APPLICATION NO.	FILING DATE	FIRST NAMED INVENTOR	ATTORNEY DOCKET NO.	CONFIRMATION NO.
10/579,146	02/22/2007	Michael Mahoney	101896-0474	8927

Office Action Summary	Application No. 10/579,146	Applicant(s) MAHONEY ET AL.	
	Examiner Larry E. Waggle, Jr	Art Unit 3775

DETAILED ACTION

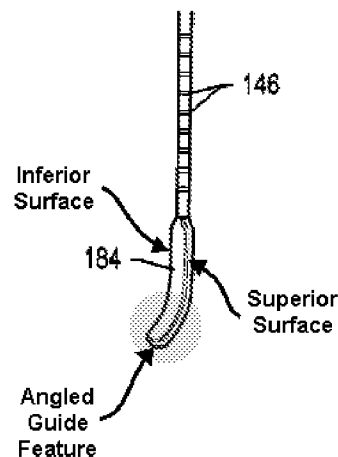
Webb discloses a surgical instrument system (Figures 13A and 13B) comprising an instrument (182) capable of maintaining a distraction between vertebrae including a shaft (186) and a paddle (184) having inferior and superior surfaces (see annotated

Figure below) located on a distal end of the shaft; an implant inserter (190) having a distal end (i.e. tip of 192); and an access port (paragraph 0081), wherein the paddle and shaft present a guide surface (i.e. left surface of 184 as shown in Figure 10) and a guide feature (i.e. left surface of 186 as shown in Figure 10) for guiding the placement of the implant and interaction with the distal end of the inserter and an angled guide feature (see annotated Figure below) integral with the distal portion of the paddle to guide an implant (100) through a partial rotation to a desired angle and the paddle includes a first height (i.e. width of left surface of 184 as shown in Figure 10) and a second height (i.e. thickness of 184 as shown in Figure 13A) greater than the first height (Figures 10-13D and paragraphs 0072-0090).
